SAFETY RECALL BULLETIN

NHTSA RECALL 20V687

AUTOCAR, LLC SAFETY RECALL ACX-2007

Autocar has determined that a safety defect may exist with the engine grounding cable.

Figure 2, Left Side (Wheel Removed for Clarity)

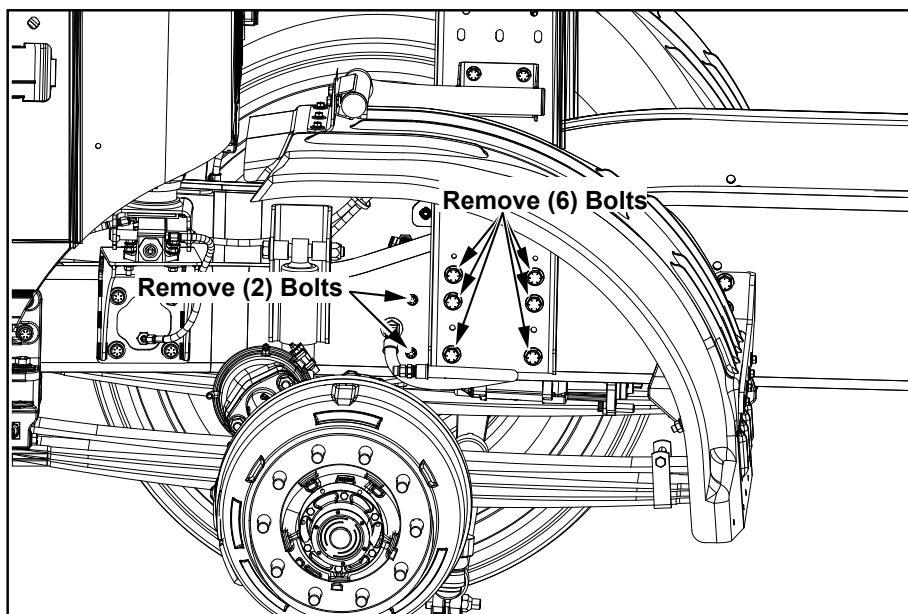
4. Locate, remove and discard the 8 bolts and nuts as indicated (see *Figure 2*).

Figure 3

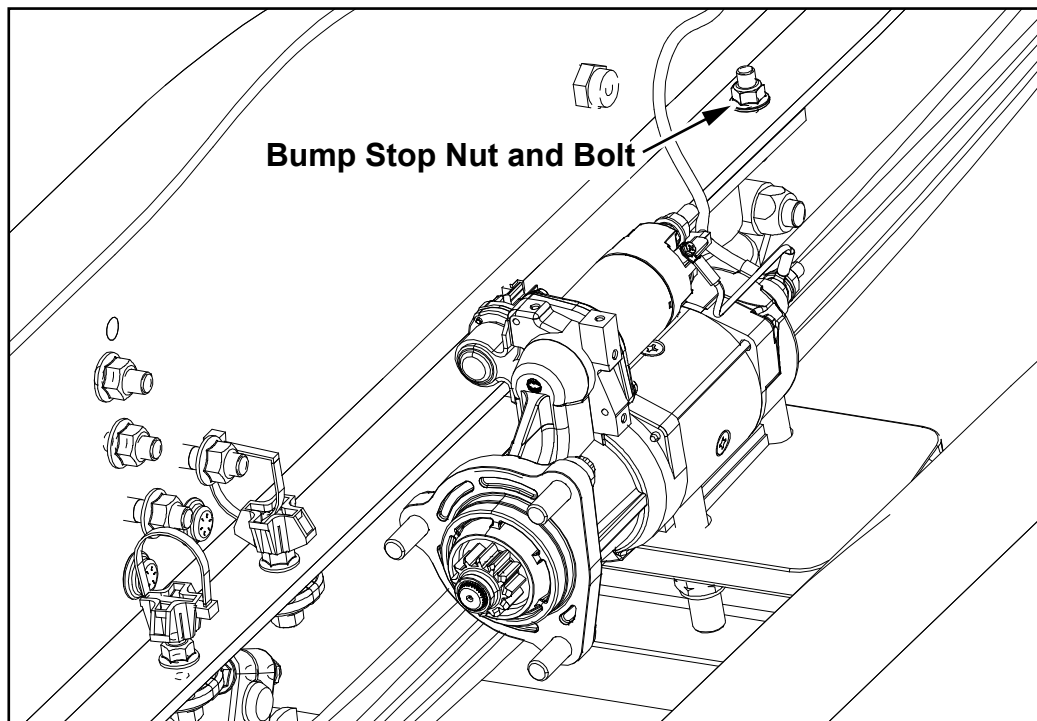
5. Remove and discard the forward bump stop bolt and nut (see *Figure 3*).

Figure 4, Starter Left Inboard Side (Harnesses Removed for Clarity)

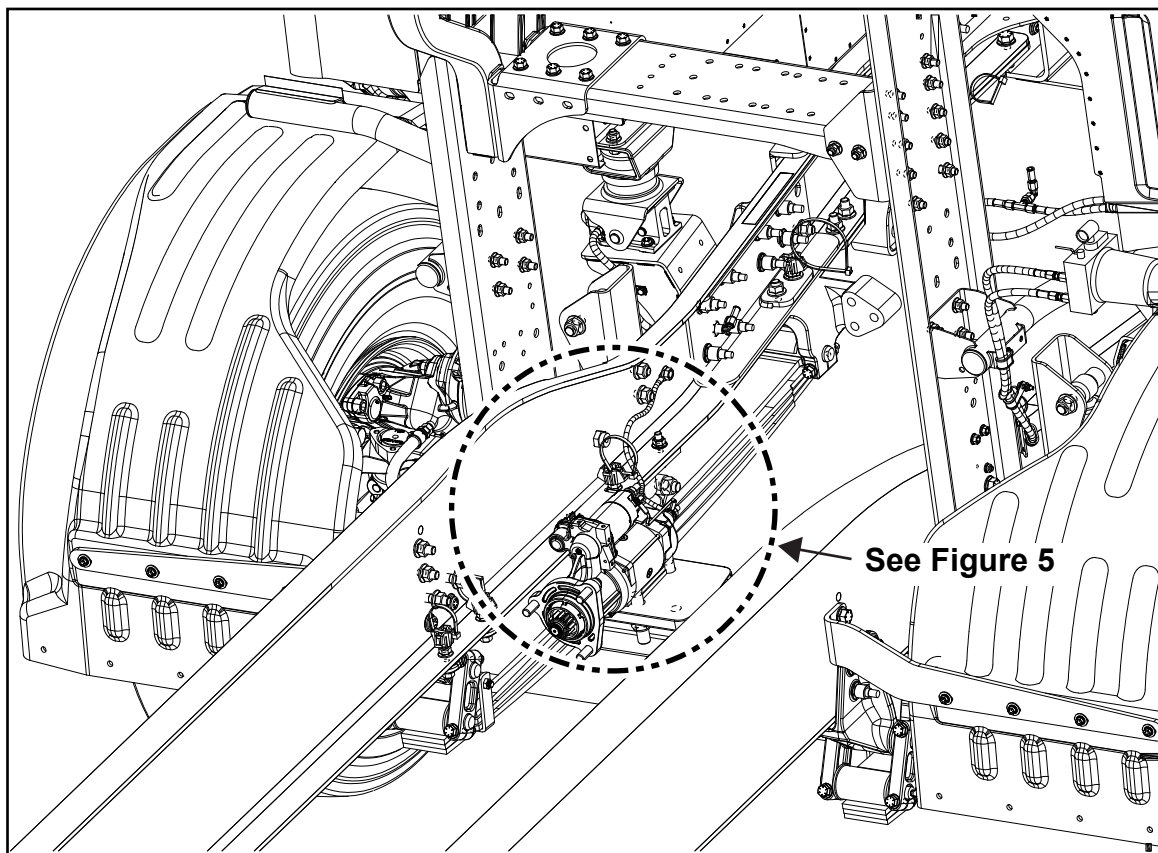
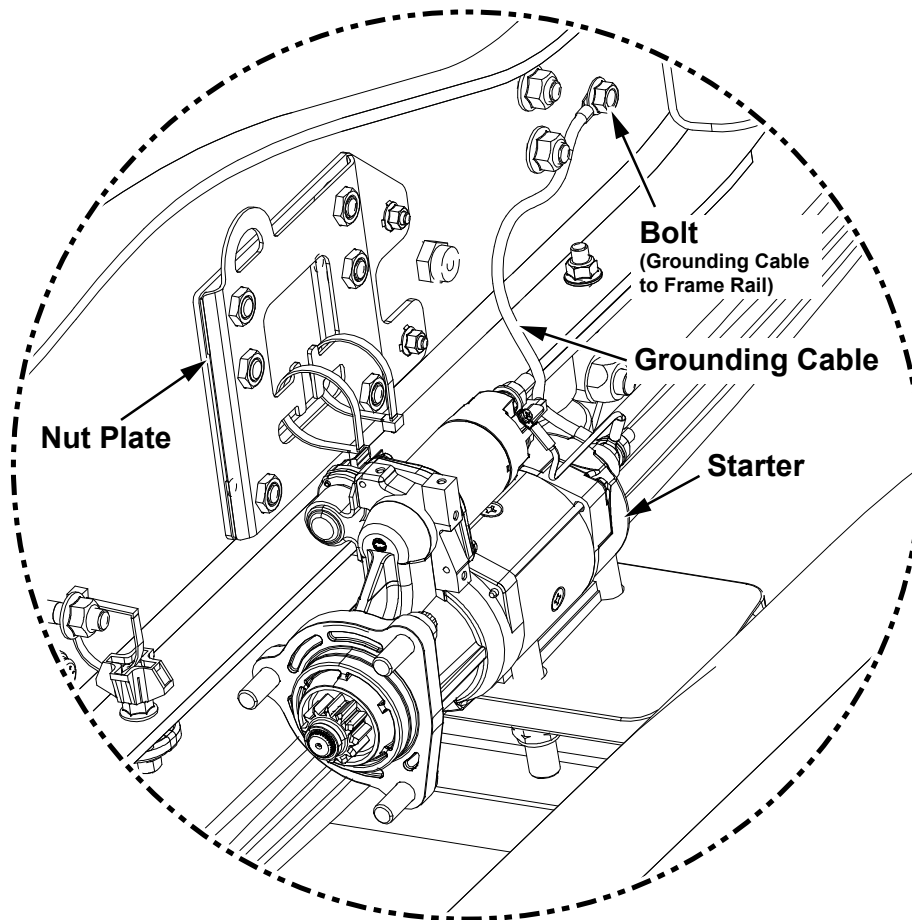
6. Install the A2290223-002 nut plate using (6) FE410162AW16 bolts and tighten to 200 lb-ft of torque (see *Figures 4 and 5*).
7. Install (2) FE410137AW14 bolts and tighten to 37 lb-ft of torque (see *Figures 4 and 5*).
8. Locate the grounding cable at the forward end of the starter, remove the bolt attaching the grounding cable to the frame rail and the nut attaching the grounding cable to the starter, and set aside the nut and bolt for re-installation (see *Figures 4 and 5*).
9. Remove the grounding cable and discard (see *Figures 4 and 5*).

10. Install the S8721017-002 grounding cable to the starter and reinstall the bolt and nut set aside in step 8 (see *Figure 5*).

Figure 6

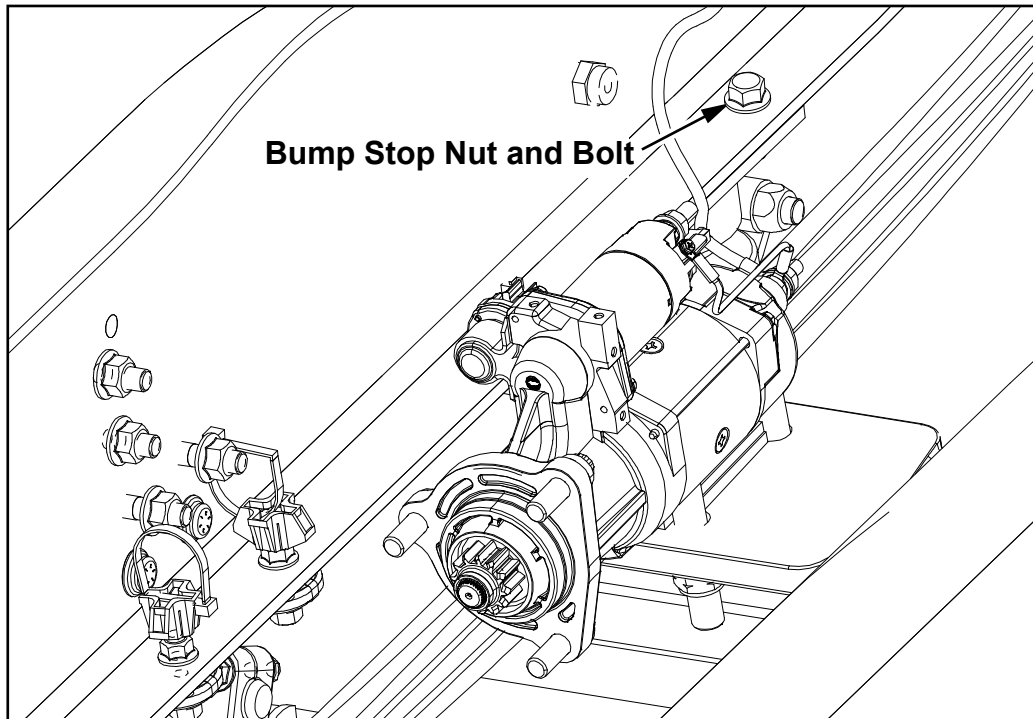
11. Install the FE410150AW15 bolt and the FE286250BW01 nut in the orientation shown and torque to 105 lb.-ft (see Figure 6).

Figure 7, Starter Left Inboard Side (Harnesses Removed for Clarity)

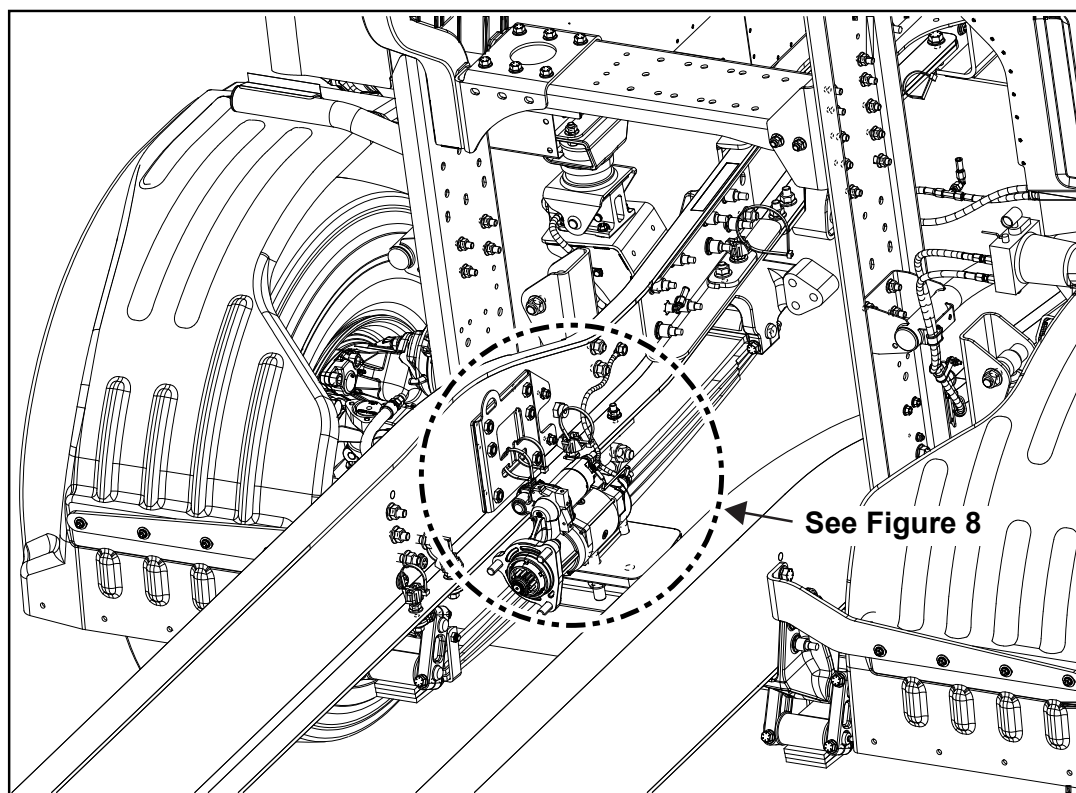
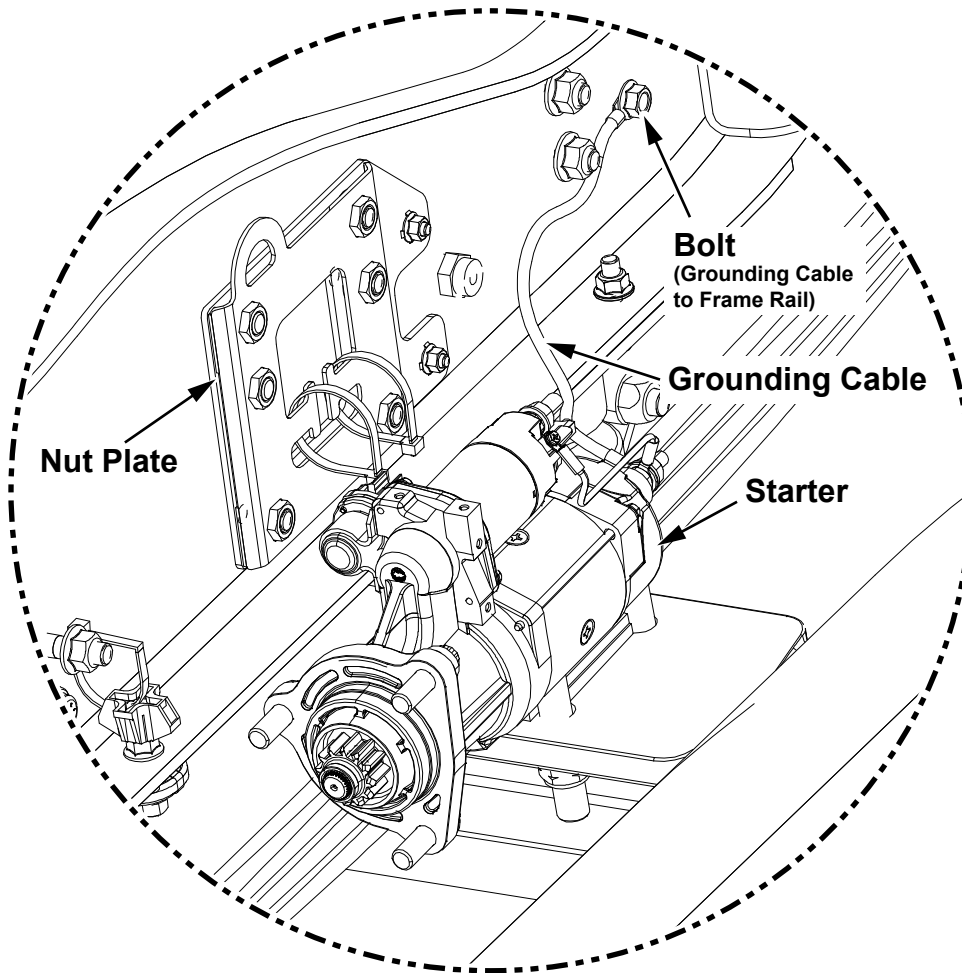
1. Follow all lockout/tagout procedures and raise the cab as in Section 1, step 1 thru step 5.
2. Locate the grounding cable at the forward end of the starter, remove the bolt attaching the grounding cable to the frame rail and the nut attaching the grounding cable to the starter, and set aside the nut and bolt for re-installation (*see Figures 7 and 8*).
3. Remove the grounding cable and discard.
4. Install the S8721017-002 grounding cable to the starter and reinstall the bolt and nut set aside in step 2 (*see Figures 7 and 8*).

Figure 9

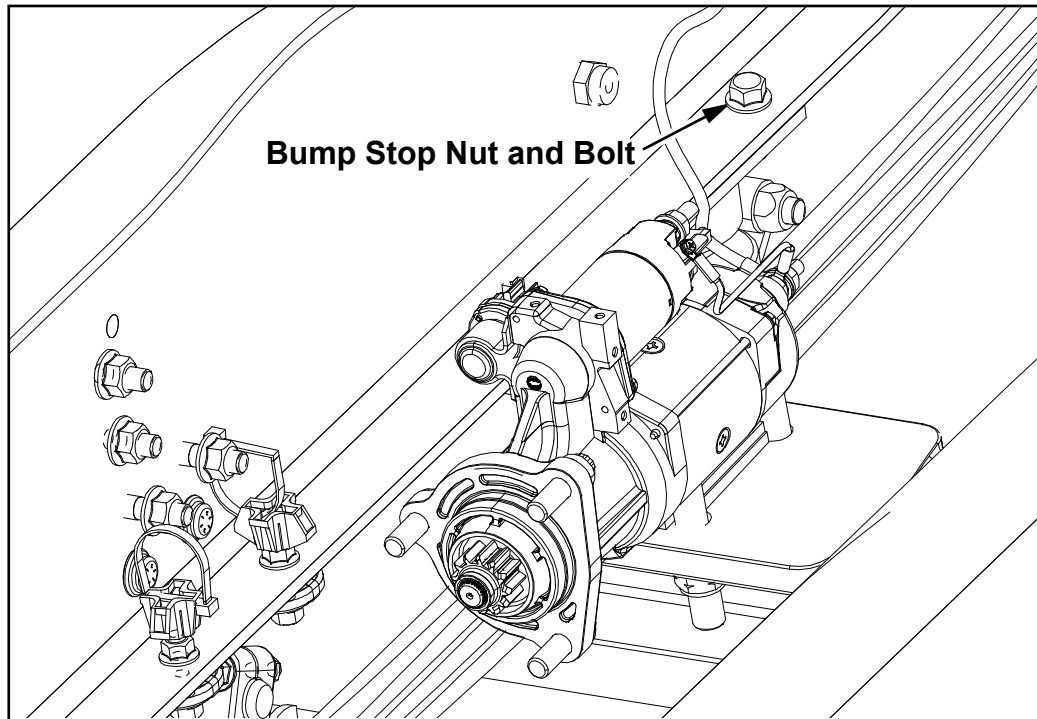
5. Install the FE410150AW15 bolt and the FE286250BW01 nut in the orientation shown and torque to 105 lb.-ft (see Figure 9).
